Section 34 Agreement

351-53 New South Head Rd

Ground Floor Plan

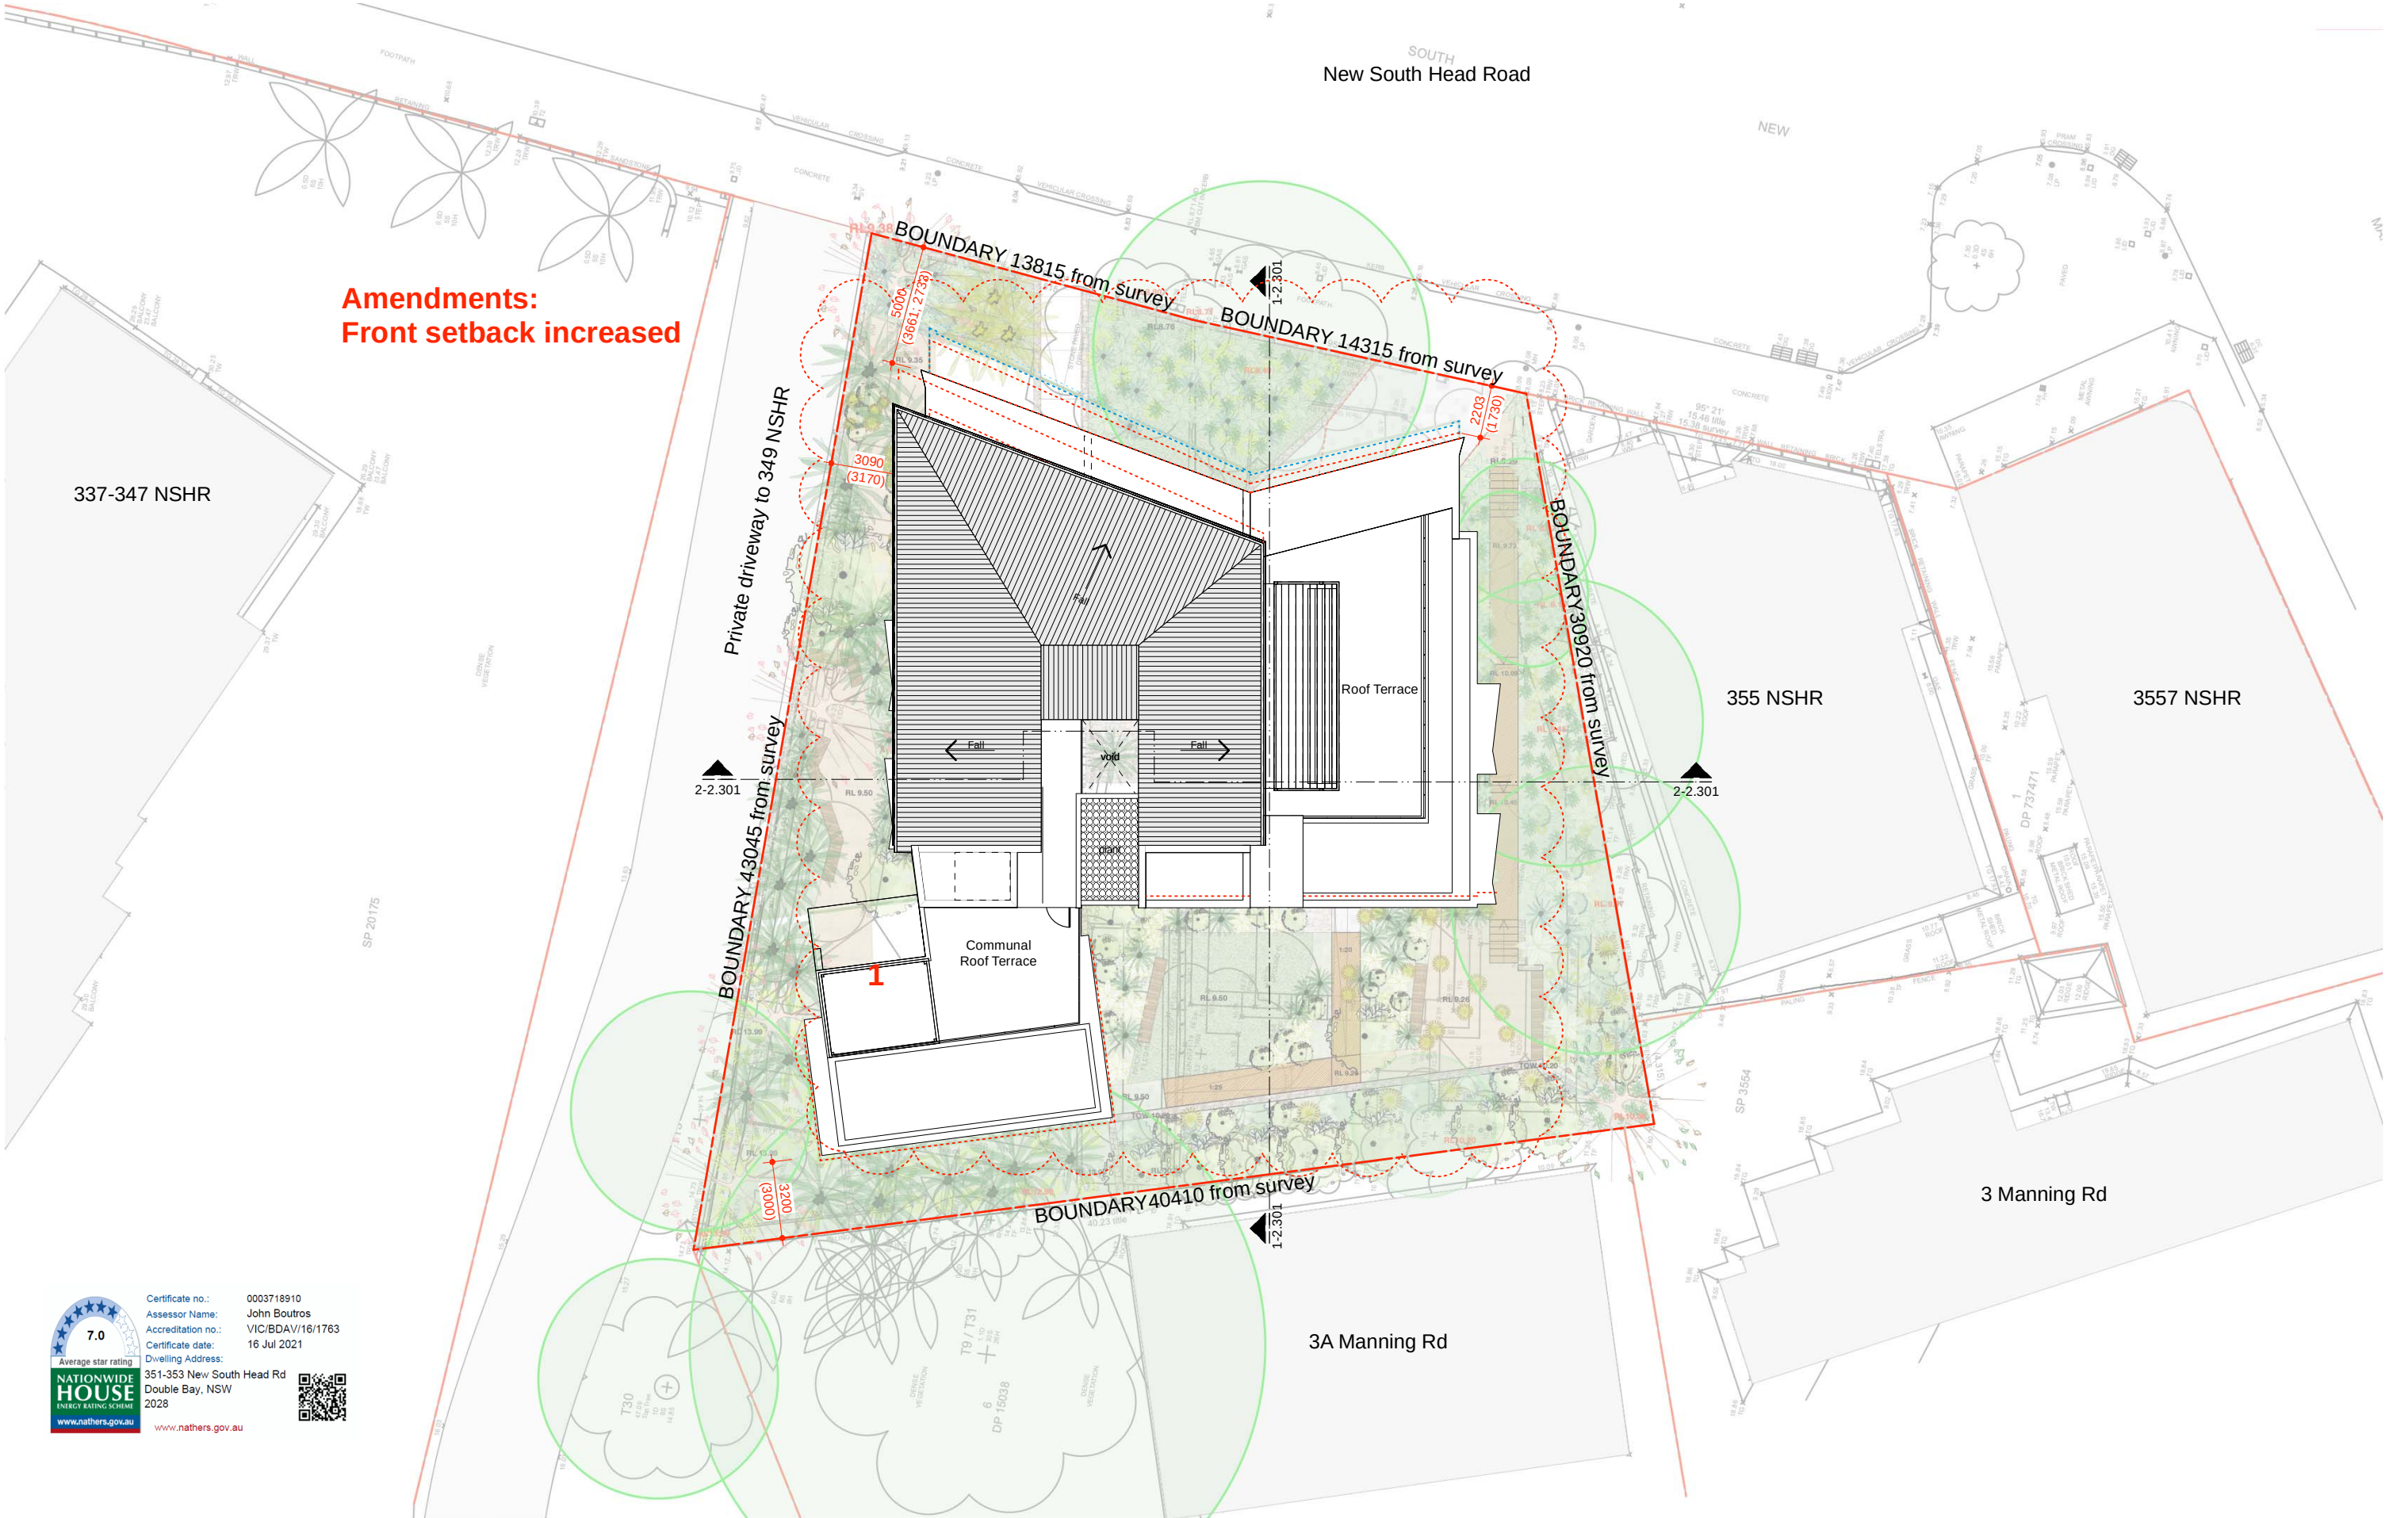
Amendments:
Front setback increased

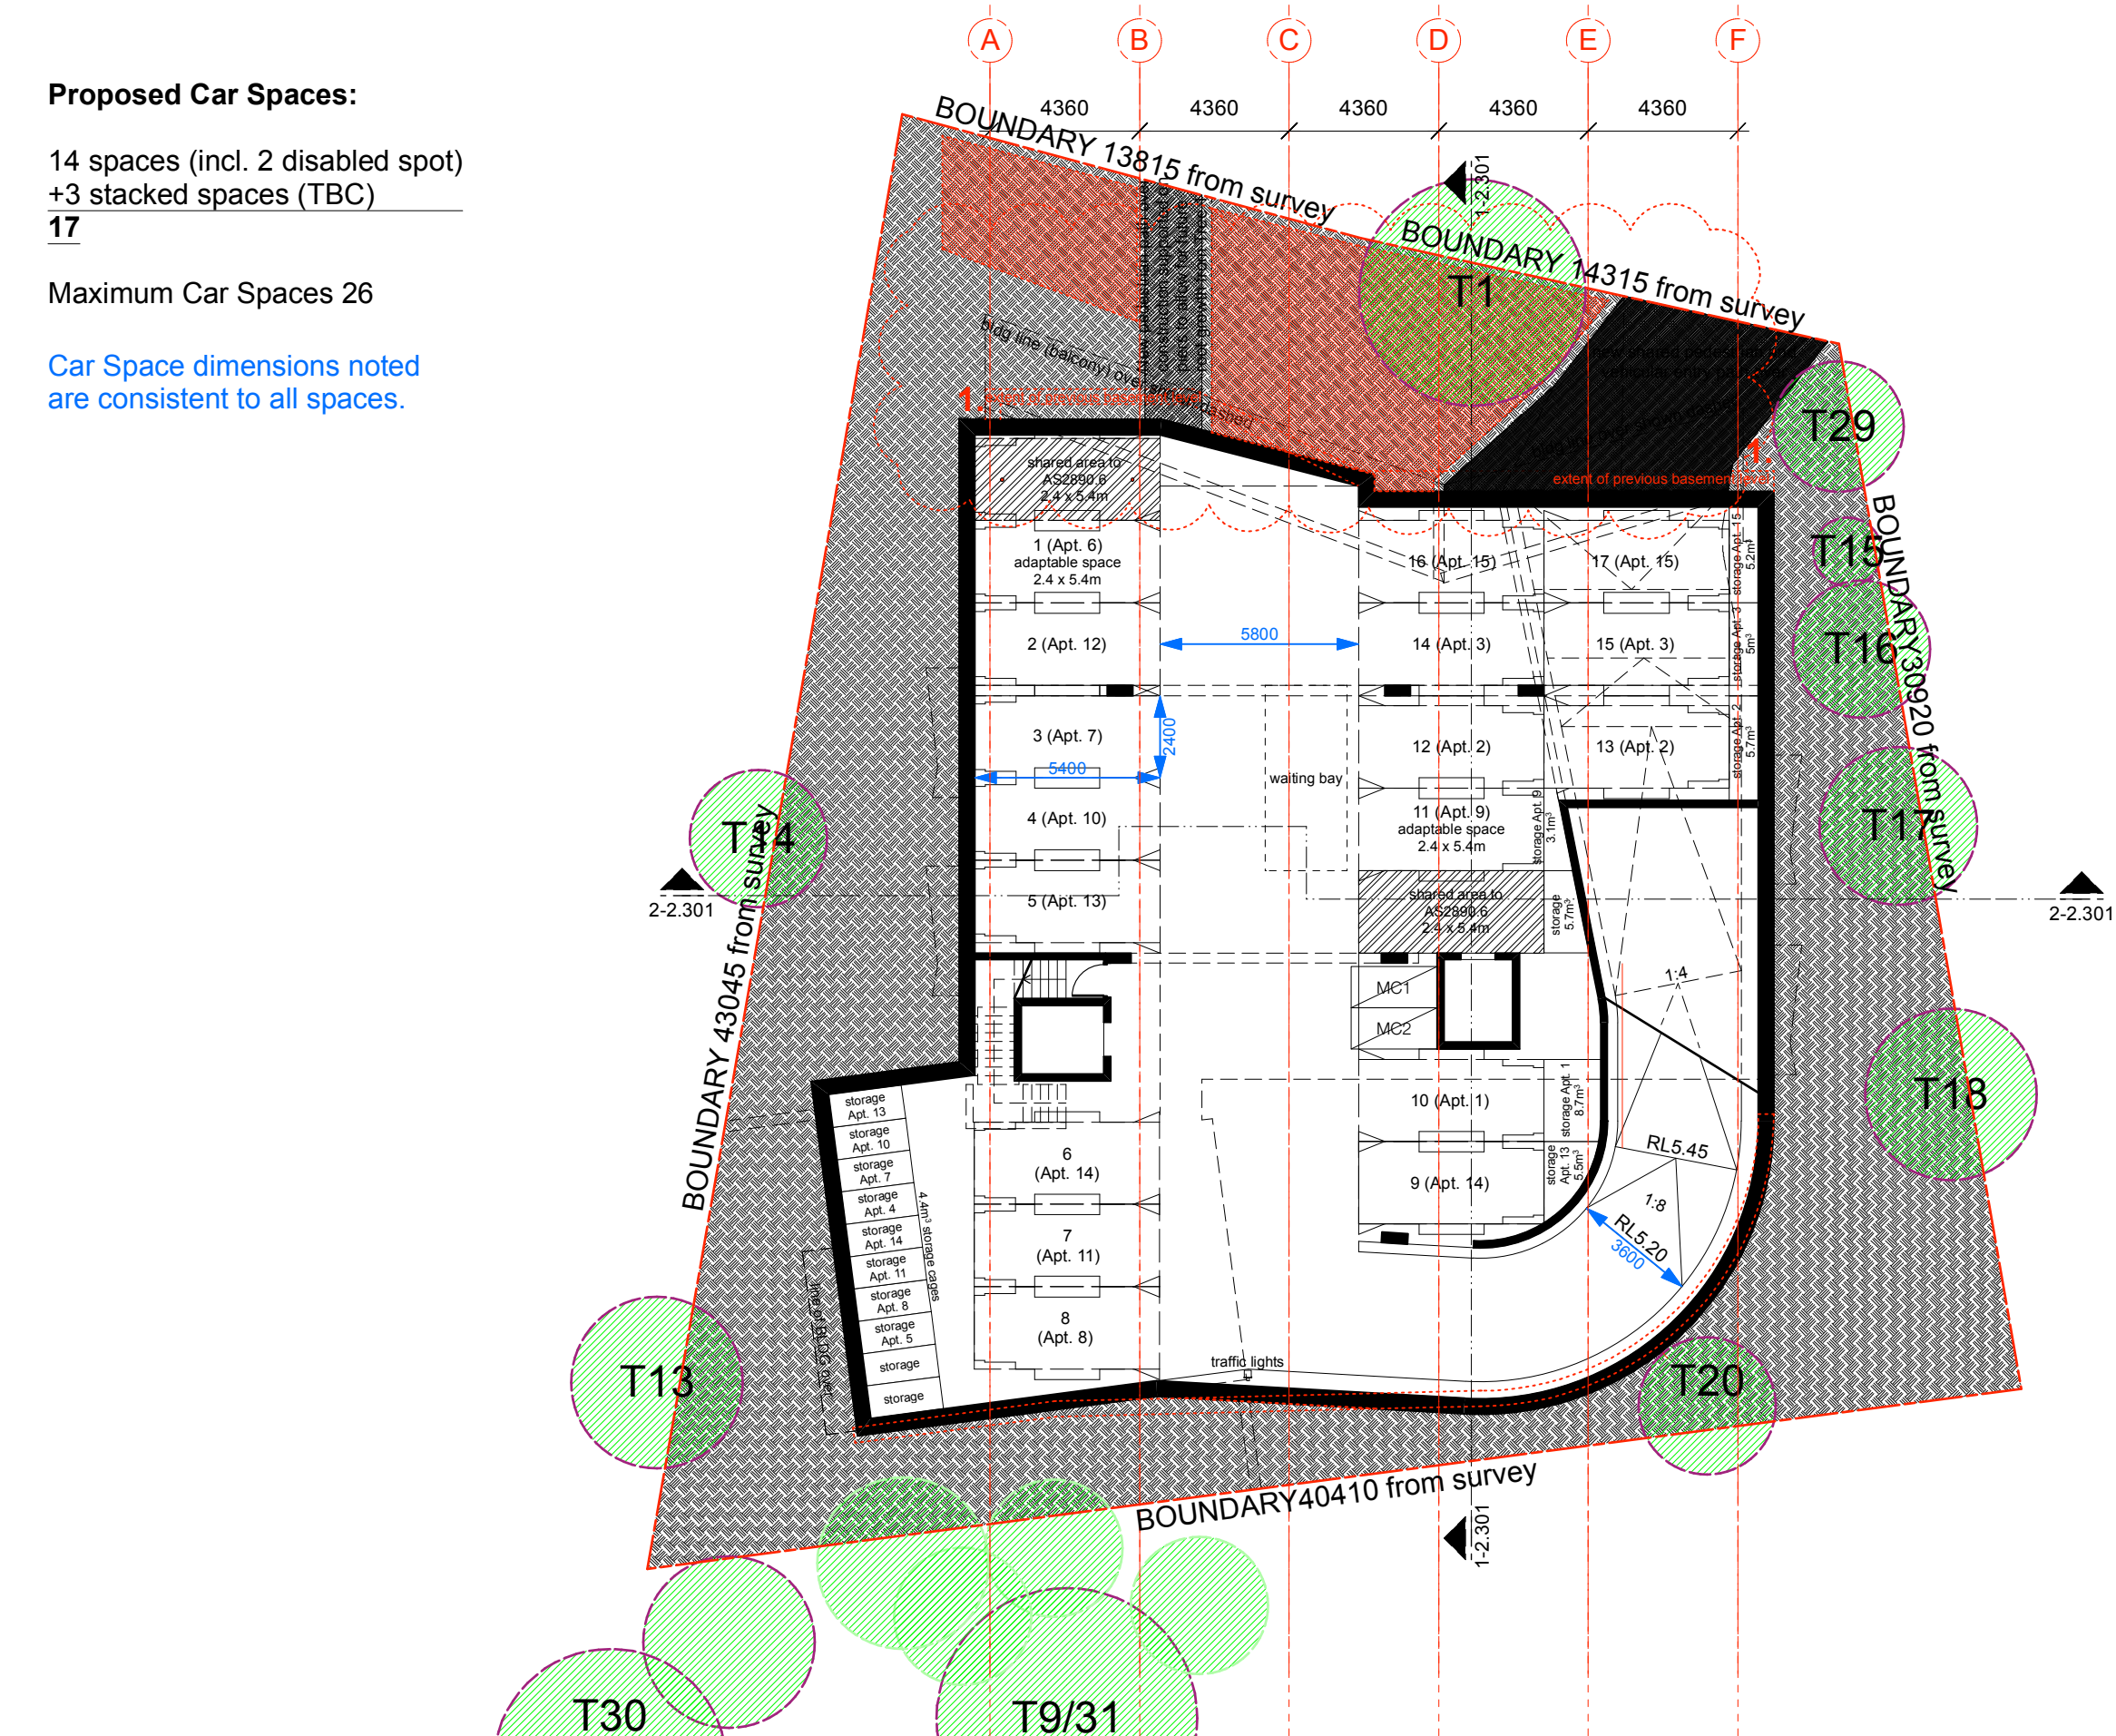
Note:
1. Front setback increased

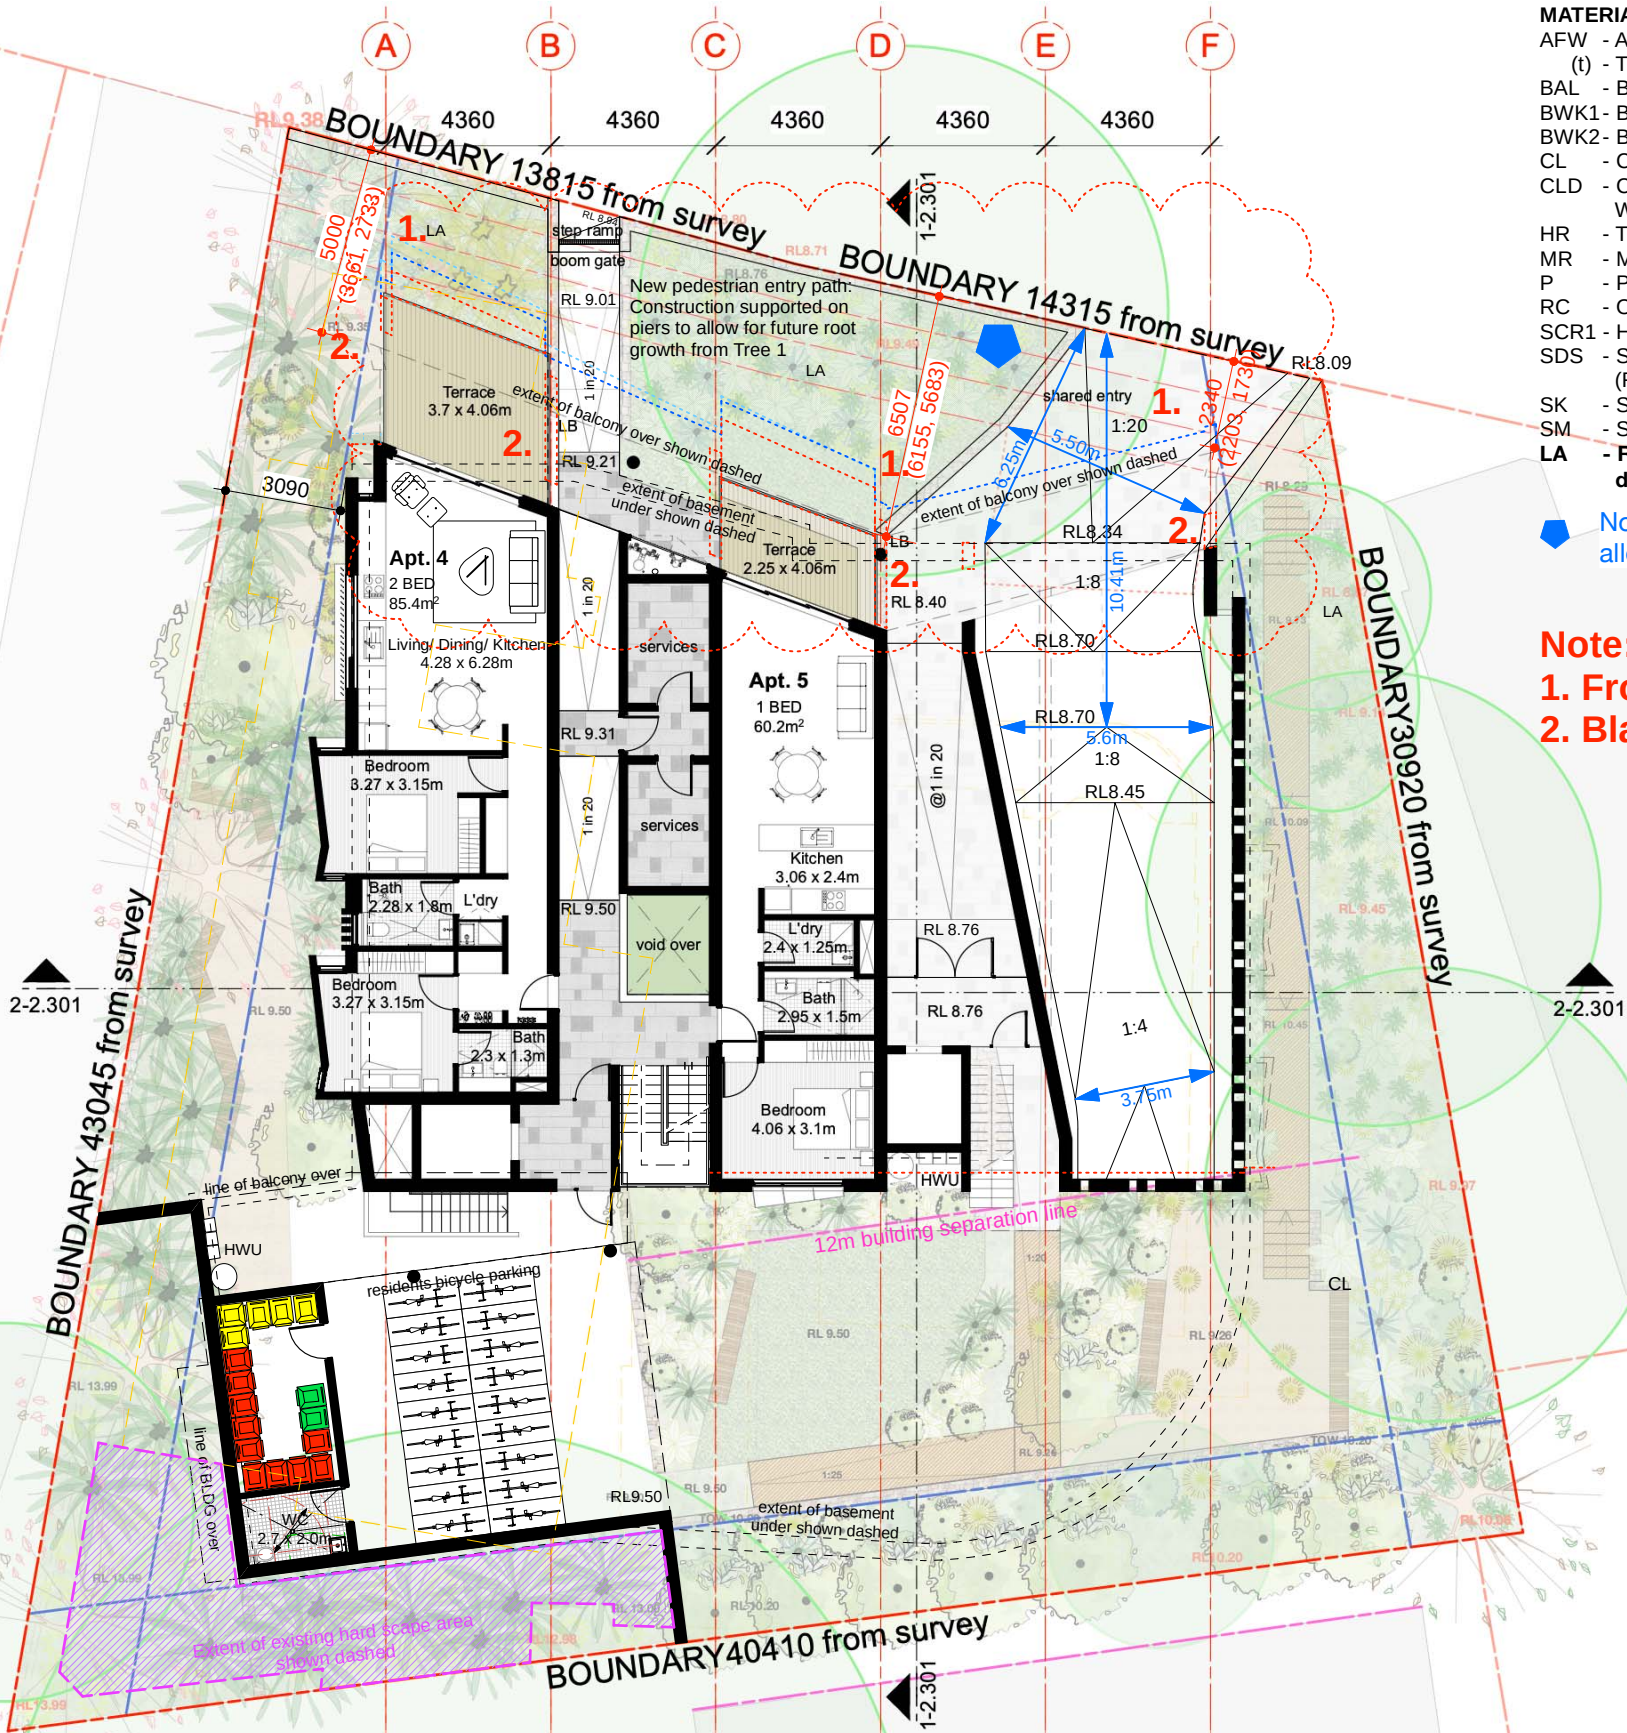
Note:
1. Front setback increased
2. Blade walls and columns removed
